CATHCART TERRACE SUBDIVISION W/MODIFICATION OF STANDARDS

Updated: November 20, 2015

PROPOSED SITE PLAN

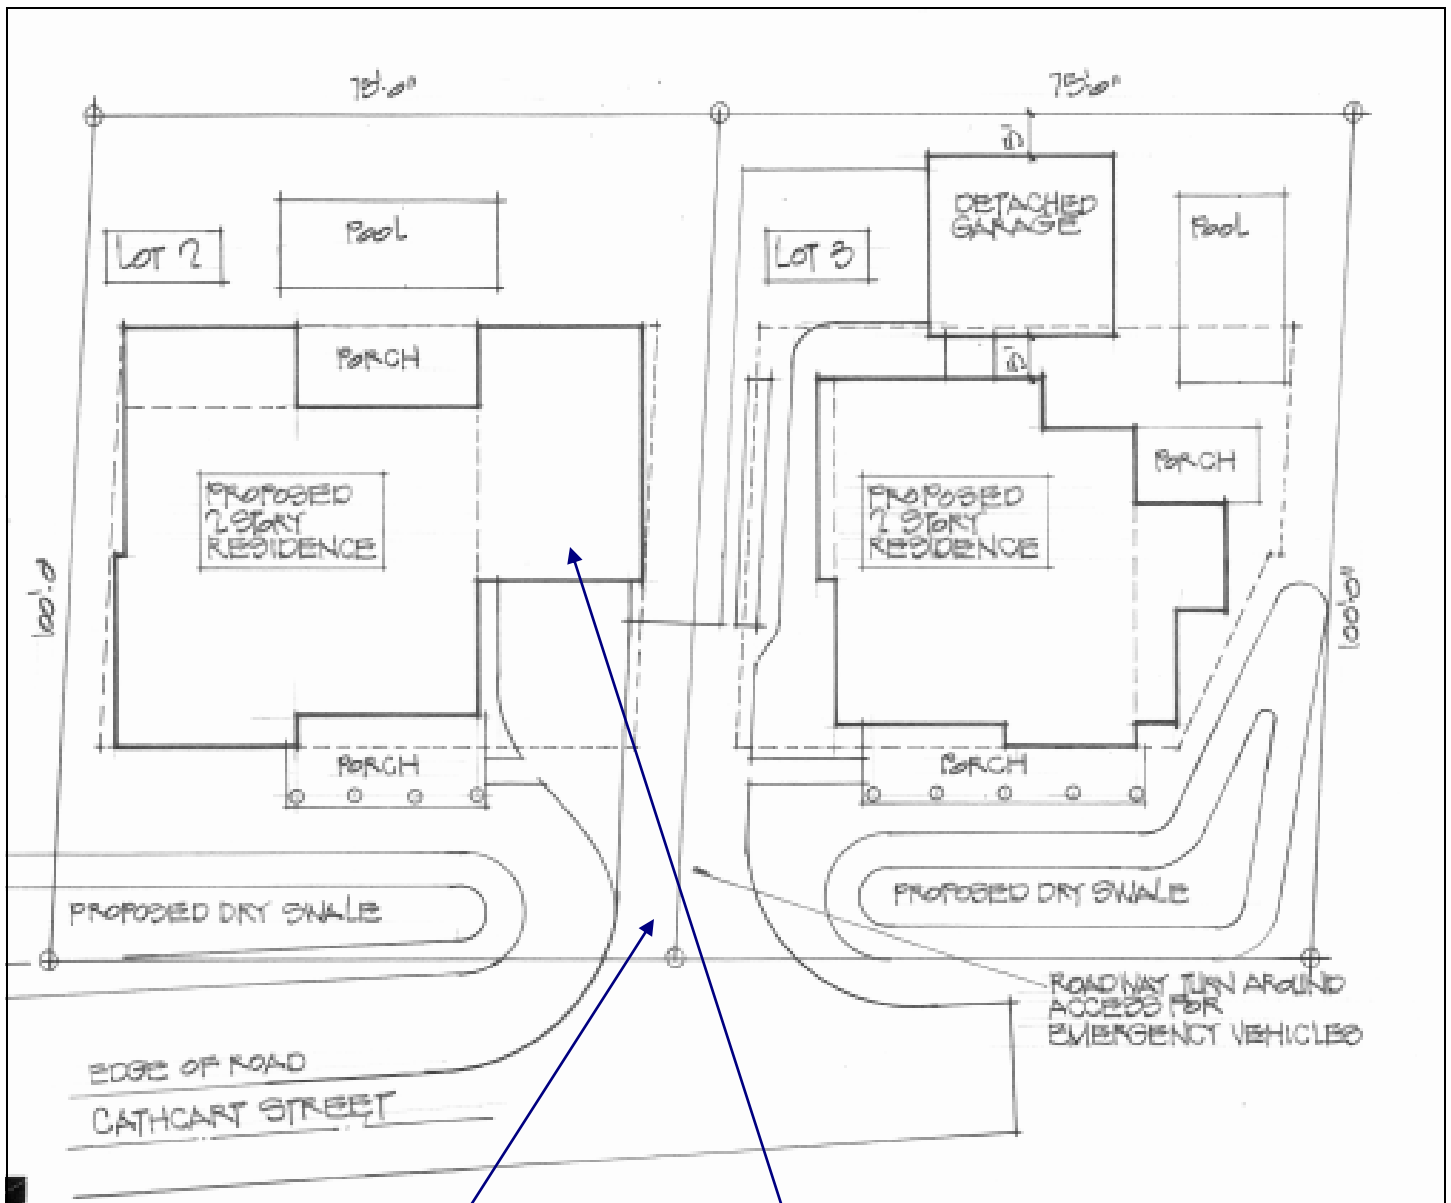
To show the proposed easement, this site plan is shown in full. The applicant has agreed to replace the attached garage on Lot 2 with a detached garage in the rear to provide ample parking space behind the required easement where no parking will be permitted. He will be allowed to create a front loaded detached garage in the rear if all other code requirements are met including ISR and setbacks. The applicant is also allowed to create Lot 3 in mirror image for Lot 2. Lastly, the applicant has agreed to erect a no parking sign in the easement.

Required 43 ft. by 24 ft. easement for emergency vehicles.

City staff condition: Must become a detached garage in the rear. May be front or side loaded. See page 11.
